**SUBJECT: Transmittal of Westinghouse Responses to Open Items Identified in the AP1000  
Draft Safety Evaluation Report**

**Westinghouse Non-Proprietary Responses to  
AP1000 Draft Safety Evaluation Report (DSER) Open Items**

# AP1000 DESIGN CERTIFICATION REVIEW

Figure 19A.2-8-1: Floor Response Spectra of ASB Node at EL. 116.50'

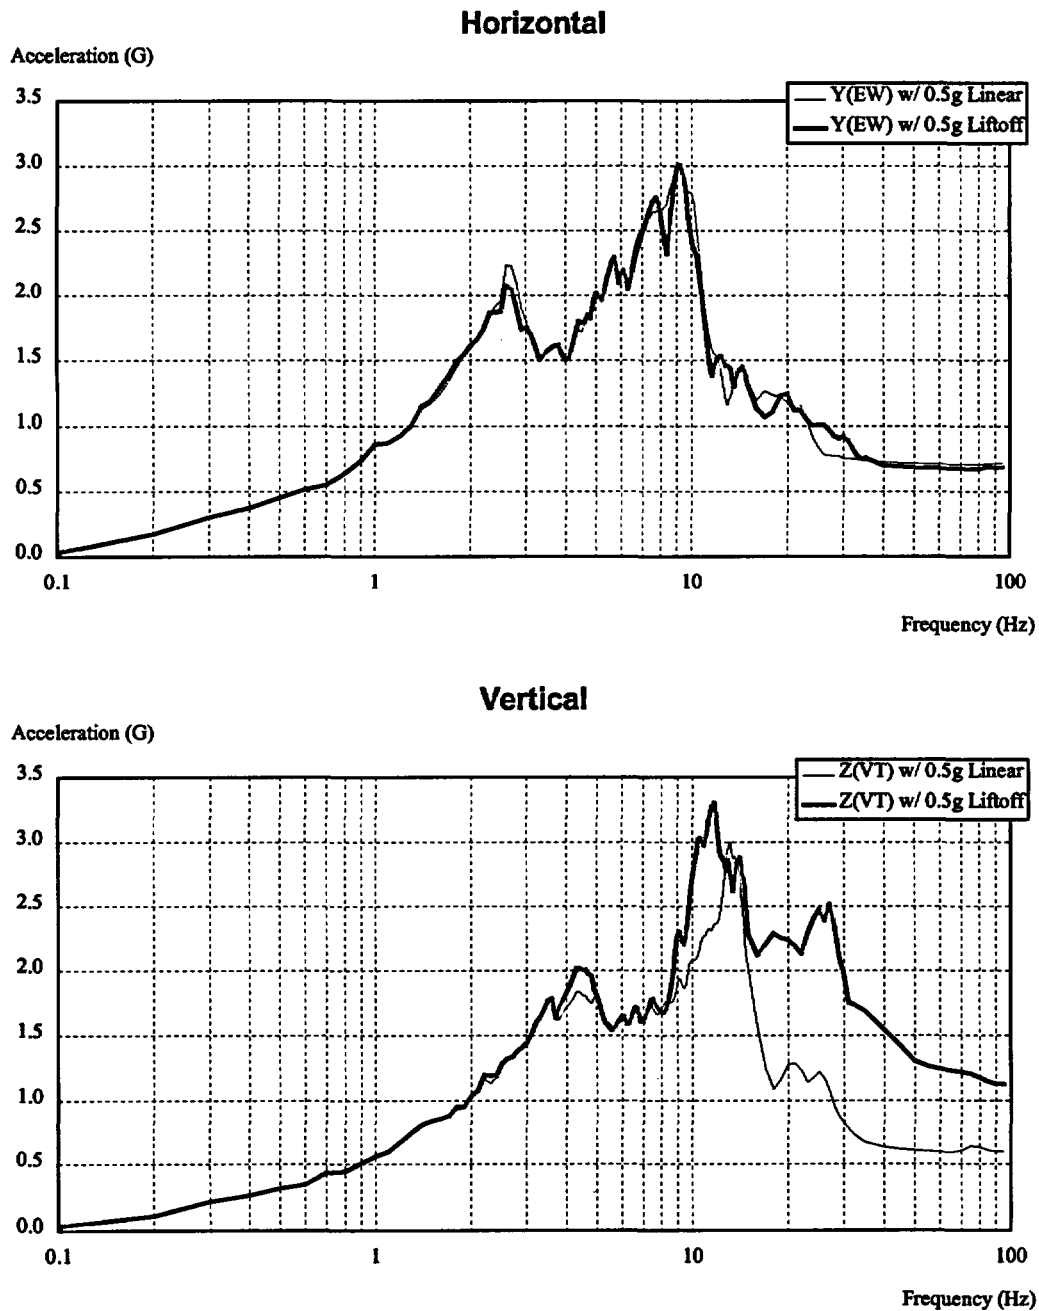
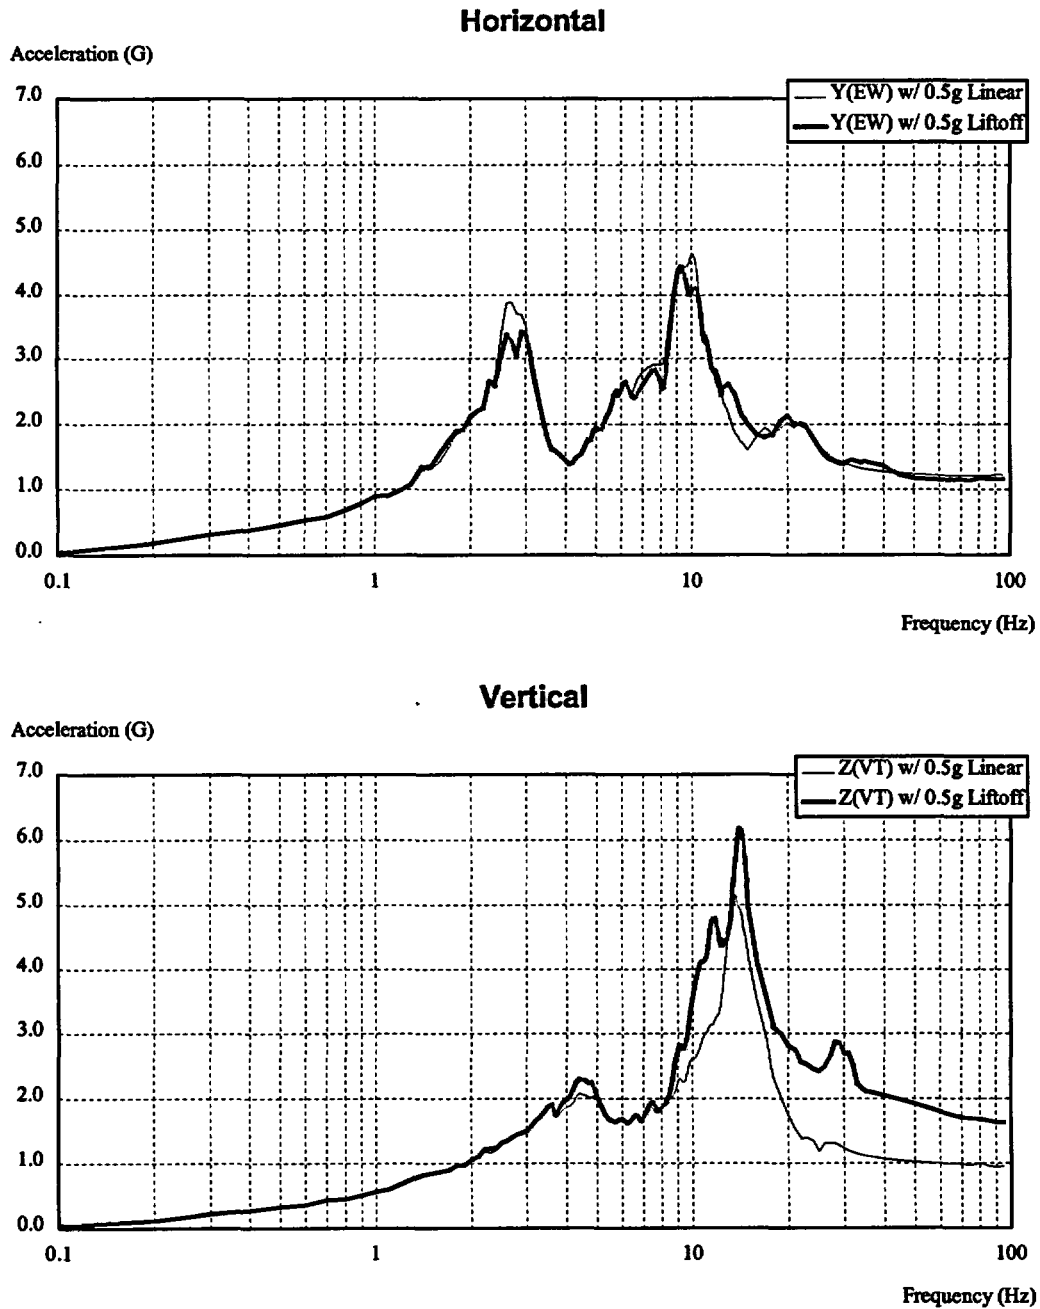
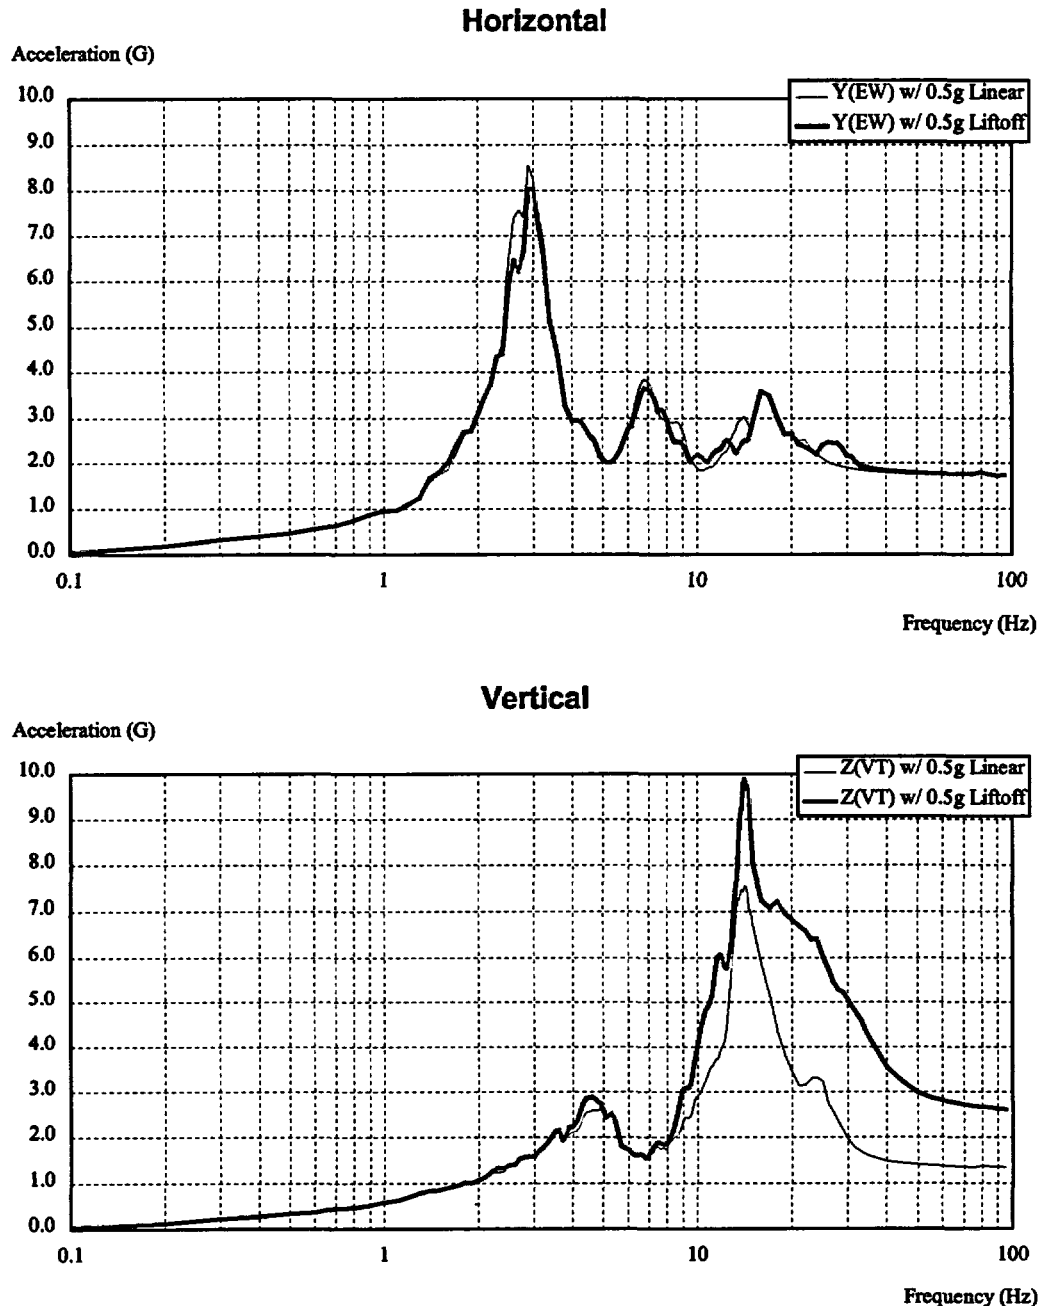
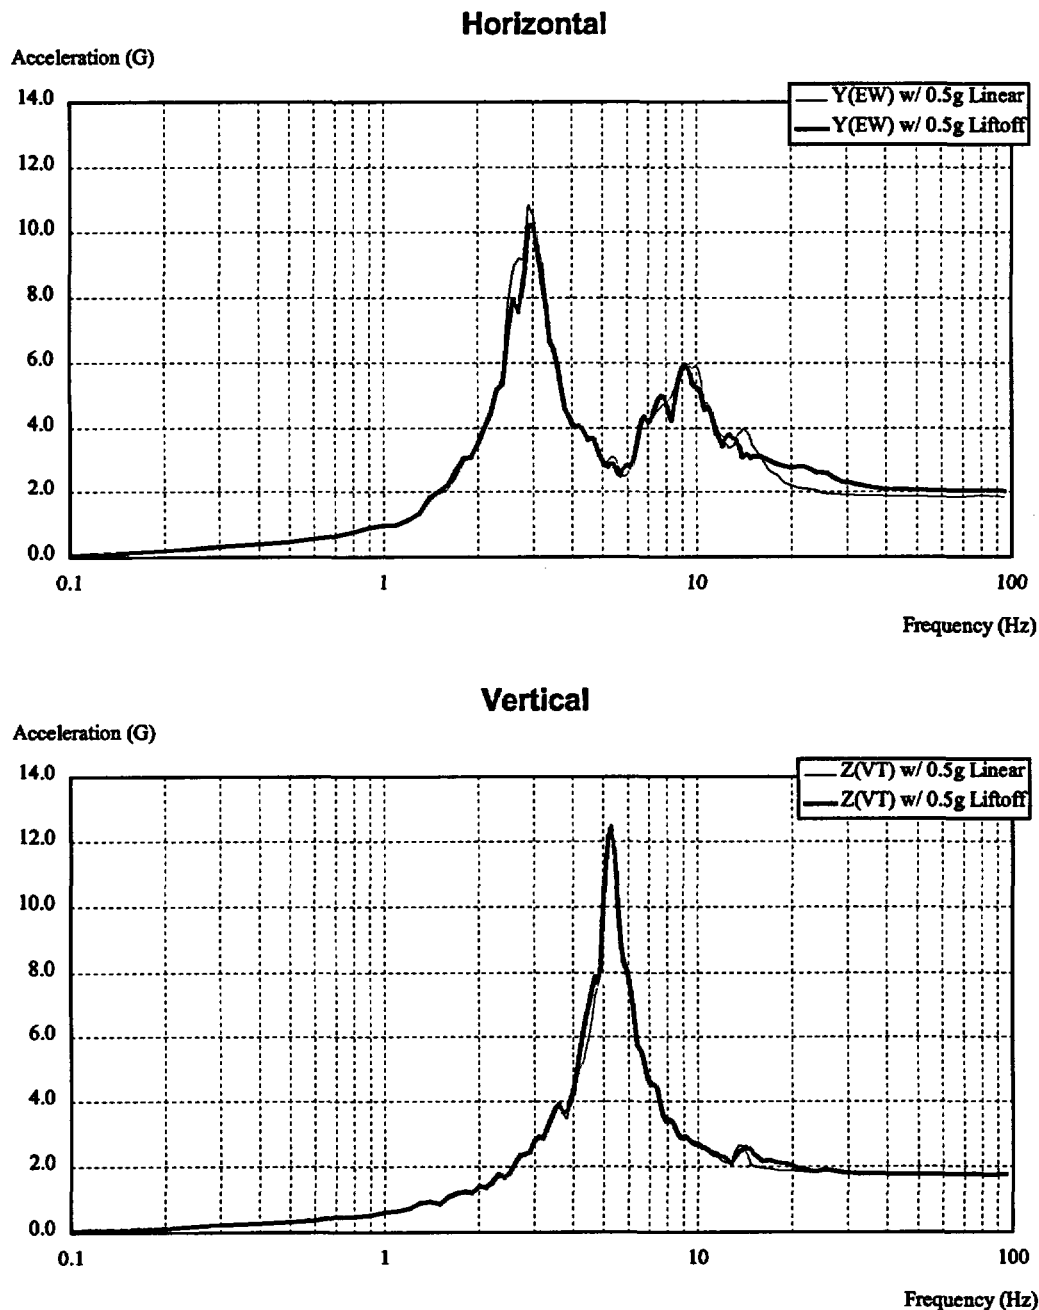
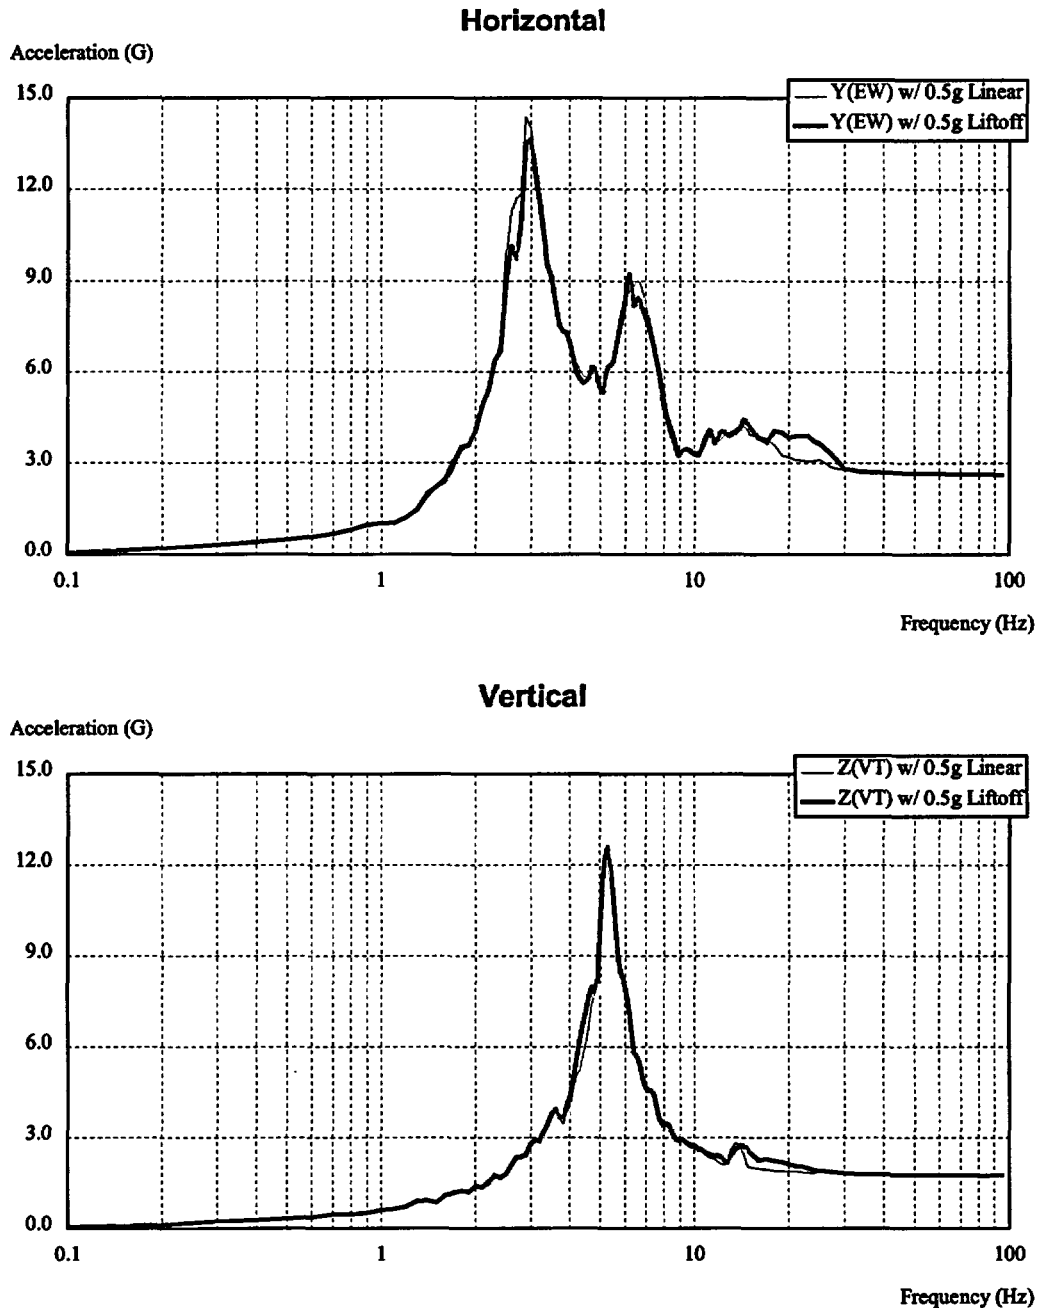
In order to make conclusions for higher seismic events ( $> 0.3g$ ), seismic response spectra (@5% equipment damping) were developed for the 0.5g case. Response spectra that include nonlinear liftoff effects were developed at different elevations using the auxiliary shield building (ASB) stick model described in DSER Open Item Number 3.7.2.3-1. The maximum uplift of the basemat is 0.29". In Figures 19A.2-8-1 to 19A.2-8-5 comparisons are made of these response spectra to the seismic response spectra using the linear ASB stick model. As seen from this comparison liftoff is not significant for horizontal response since the horizontal response spectra are similar. In the region of the shield building roof the vertical response spectra are comparable. There are differences in the vertical response spectra in the higher frequency region for the Shield Building cylinder up to elevation 265'. However, the differences shown in these curves will not affect the HCLPF values because:
